URBAN DESIGN COMMITTEE

APPLICATION NUMBER Urban Design Record #UDR26083

APPLICATION TYPE Waiver of Neighborhood Design Standards

ADDRESS/LOCATION 3000 Sumner Street

Figure 4 GIS Topographical Map

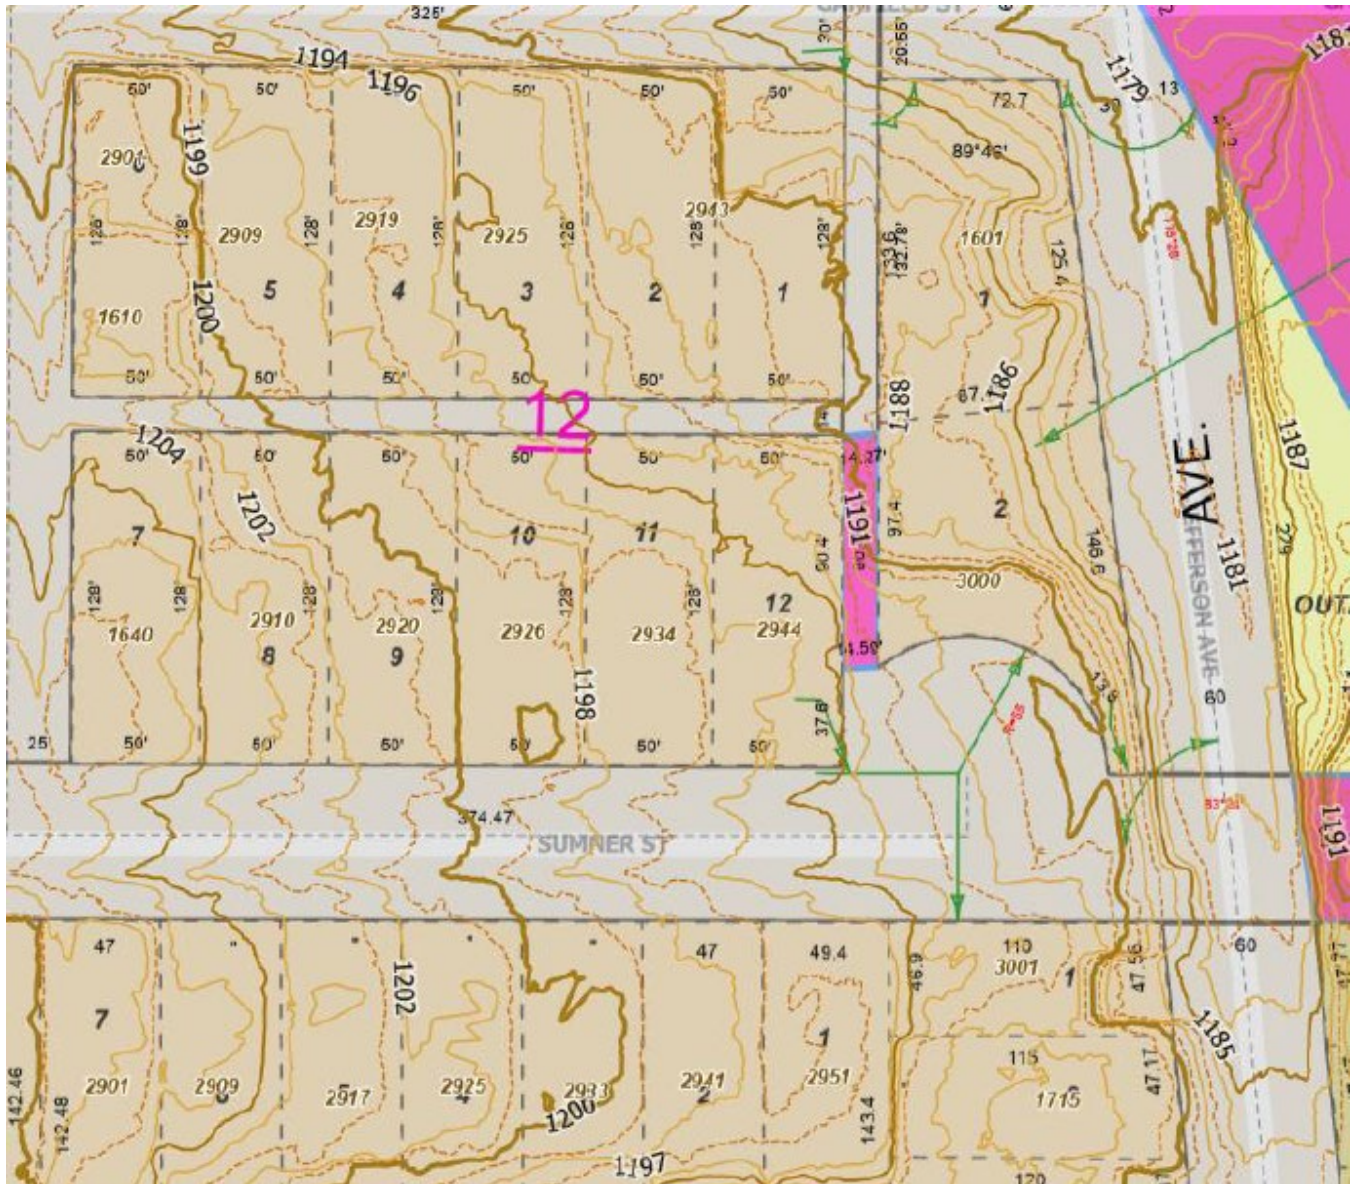
The parcel's lot depth is thirty-one feet shorter than the prevailing depth of standard interior lots on this block. The arc of the cul-de-sac cuts into the buildable envelope, and the dual street setbacks constrict the interior footprint from two directions. While the alley behind the 2900 block of Sumner exists, it does not extend all the way behind this parcel, giving only seven feet of alley frontage. In addition, physical access from the rear is infeasible due to an existing utility pole situated directly within the driveway path. The parcel also features a slope that would be hazardous for a driveway at the natural grade change, which would make navigating the driveway hazardous during winter weather. Retention of earth to adjust the slope would be expensive.

Relocating the garage from the current design on the front to the rear would require a multi-tiered structural retaining wall system and a suspended structural hollow-core concrete floor slab system to support the driveway and garage floor over the slope. The owners and designers assert the cost of these systems would constitute an excessive, non-standard burden for single-family residential construction. Likewise, a wrap-around driveway to reach the rear would use up valuable buildable space for the house.

1 SOUTH ELEVATION

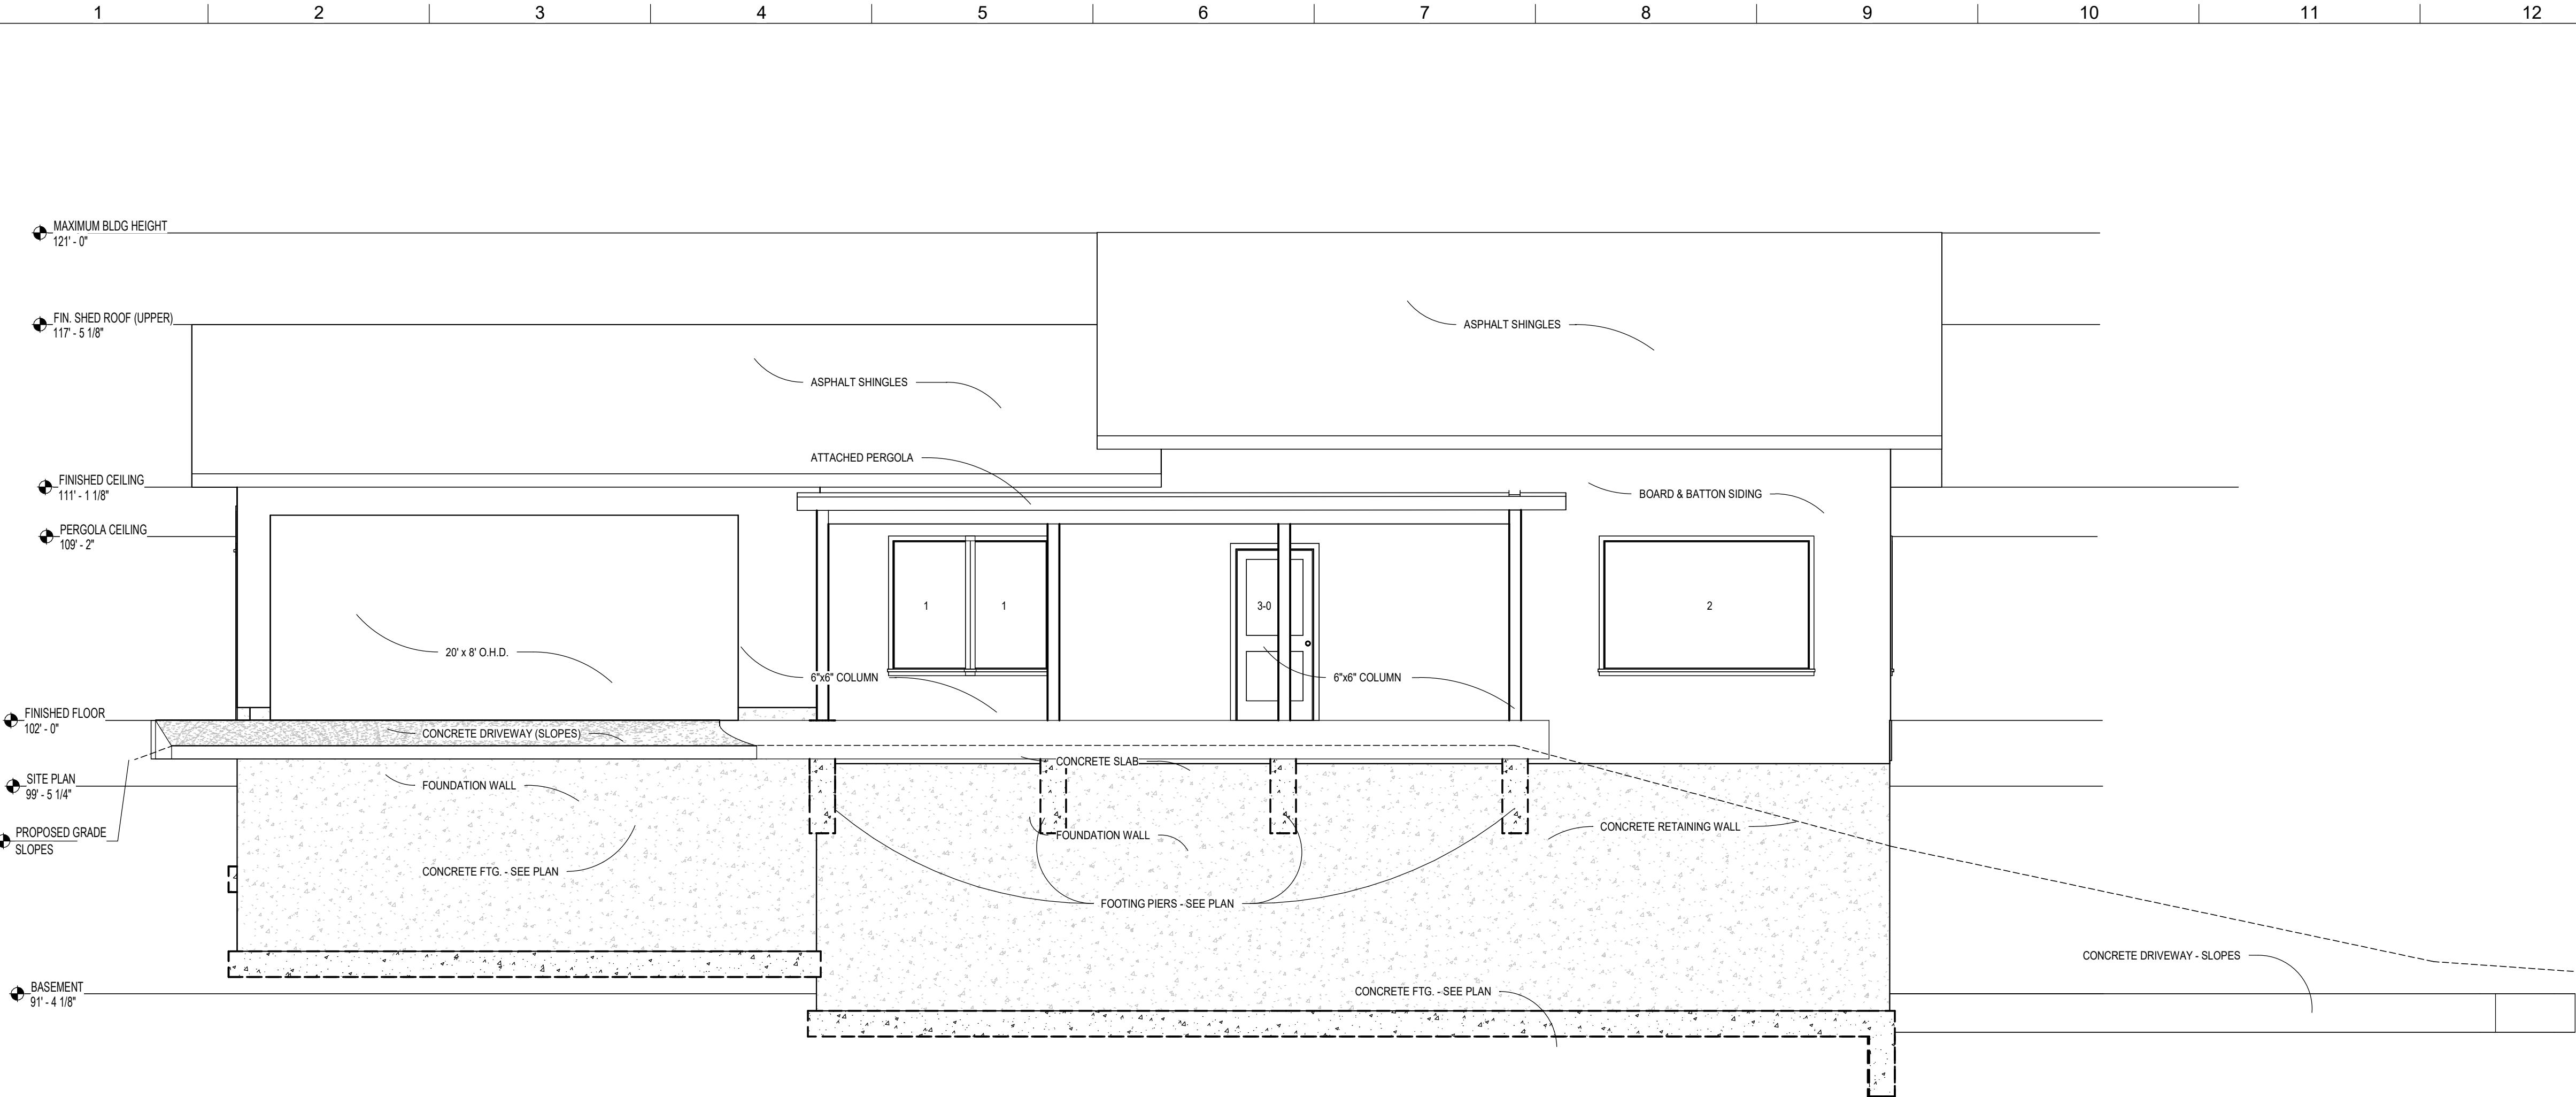
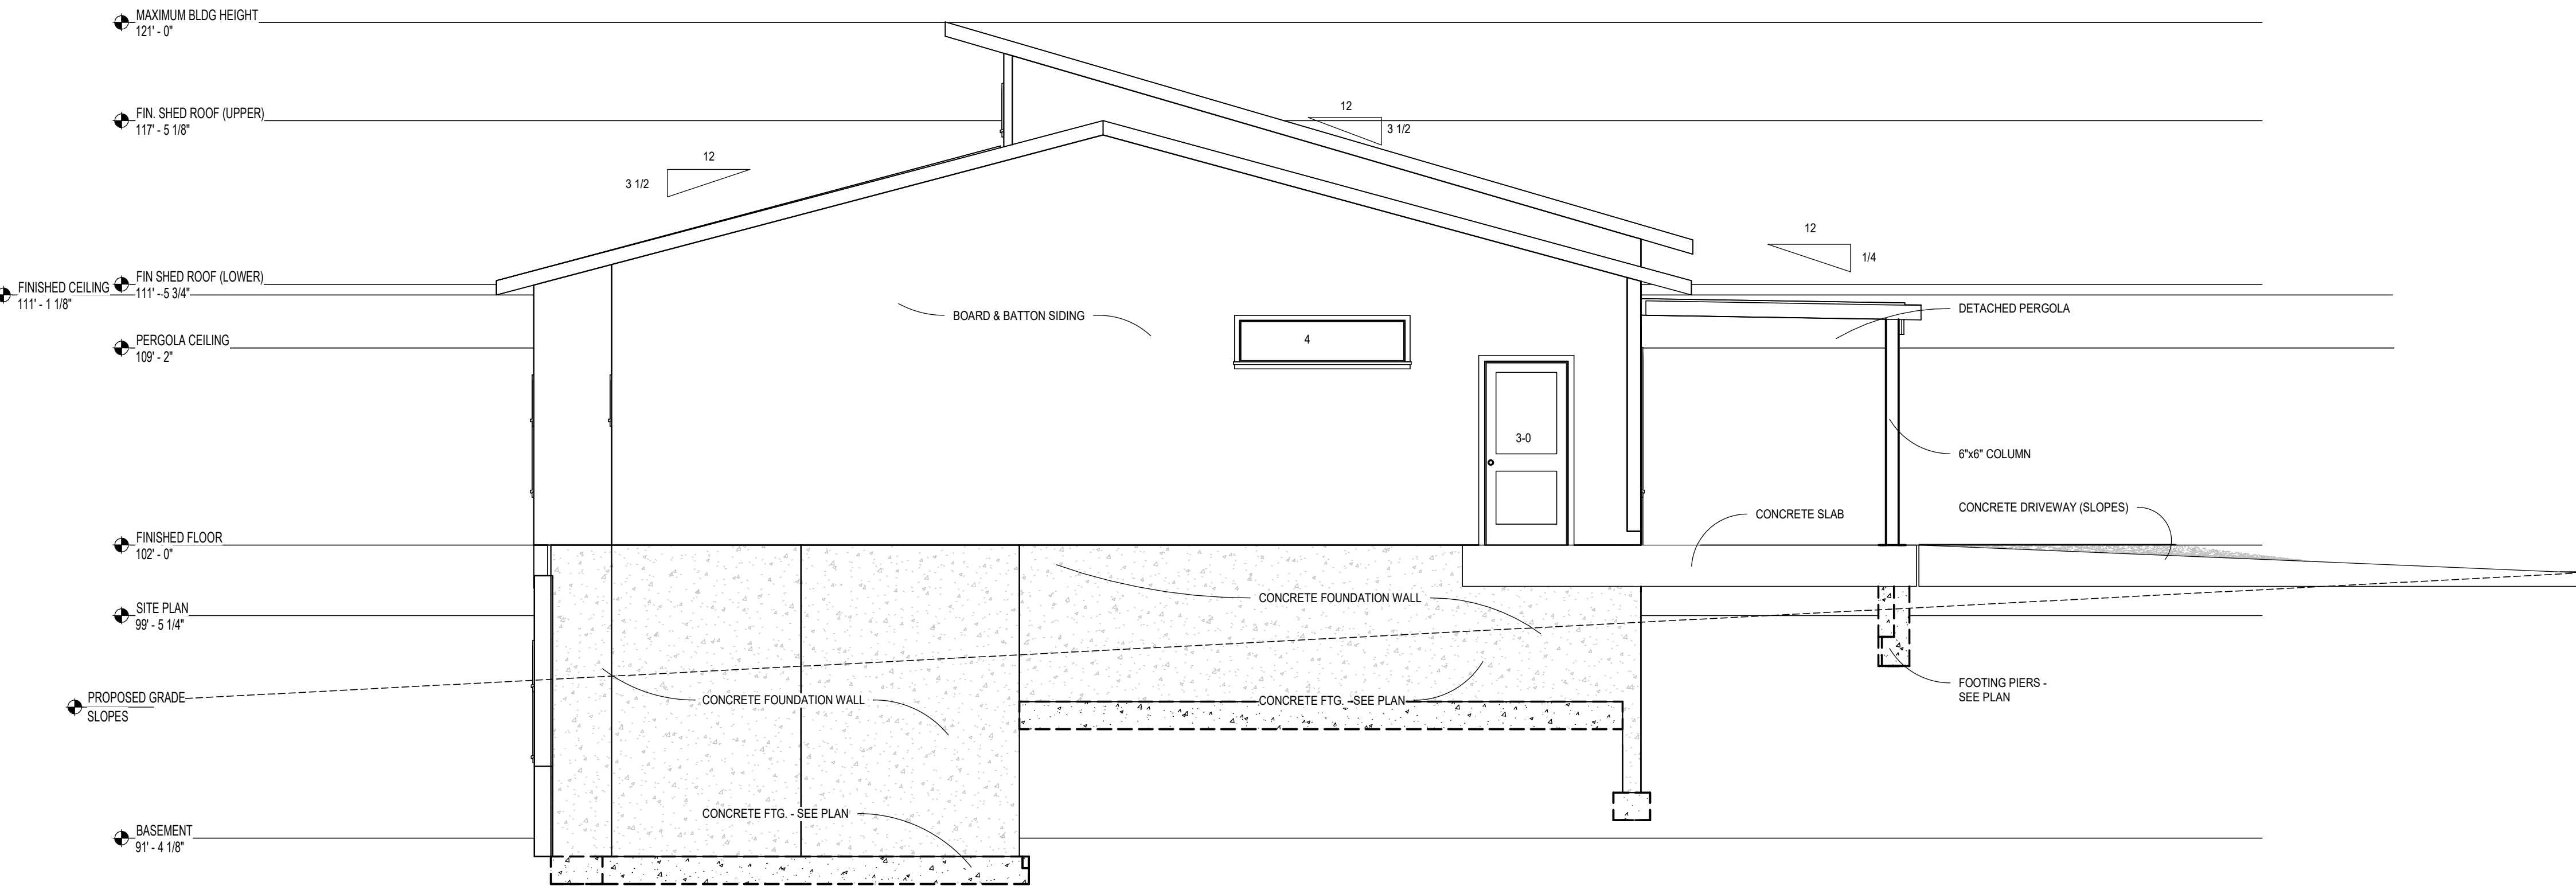
The owner proposes to design a modern two-story house with a front facing two-car garage on the west half of the front façade, and a covered porch with the front entrance on the east half. The roof has a low-pitched gable roof with a monoslope high roof. Section 4.1 of the Neighborhood Design Standards requires proposed roof types and pitches to reflect patterns found within the block front. A visual survey of the rooflines of the houses on both sides of the block yields a wide variety of roof styles, front gables, side gables, paired staggered front gables, side gables with dormers, cross gables, hips, hipped with dormers, and even a jerkinhead. There is no set pattern for this house to conform to. A number of the houses have moderate pitches to their roofs, but most feature a low pitch.

The house at 2926 Sumner Street has lower-slope roof planes (3:12-4:12), illustrating that lower-slope planes are an established architectural element along the streetscape to transition lower single-story projections down to the street level. The proposed 3:12/4:12 pitch on this roof is not inconsistent with nearby houses. The 1959 two-story modern house at 3001 Sumner, directly across the street from this lot, features a low, 3:12 gabled pitch that is the closest analog to the proposed house.

Neighborhood Design Standard 4.1.7 states that garages, if constructed, shall follow the pattern of half or more of the residential properties on the same and facing block front. The preference expressed by the design standards would be for an attached garage to be no more than two stalls on the street facing side, provided the doors occupy not more than 40% of the length of the principal street façade. Garage doors are permitted in the main plane of the façade or forward of the main plane only when documentation is provided that such a feature is the pattern of half or more of the houses in an area. While the house, as planned, still features front facing garages on the Sumner facade, the owners were willing to set the garages back behind the porch, which will soften their visual impact.

Although the neighborhood features mostly detached garages either to the side and rear of the house or off an alley, this lot does not have alley access for more than a few feet. 3001 Sumner does provide a precedent for an attached two-car garage incorporated into the body of the residence, however the garages are accessed from Jefferson Avenue, while the front door is located on Sumner. The owners would like to have a secondary garage on the east façade accessed by Jefferson Avenue, as well as the two front-facing garages on Sumner. Please note that the duplex at 1601 and 1603 Jefferson Avenue also features front facing garages.

Motion to grant a waiver for the Neighborhood Design Standards to allow the secondary low-slope roof transition and front facing garages on Sumner Street.
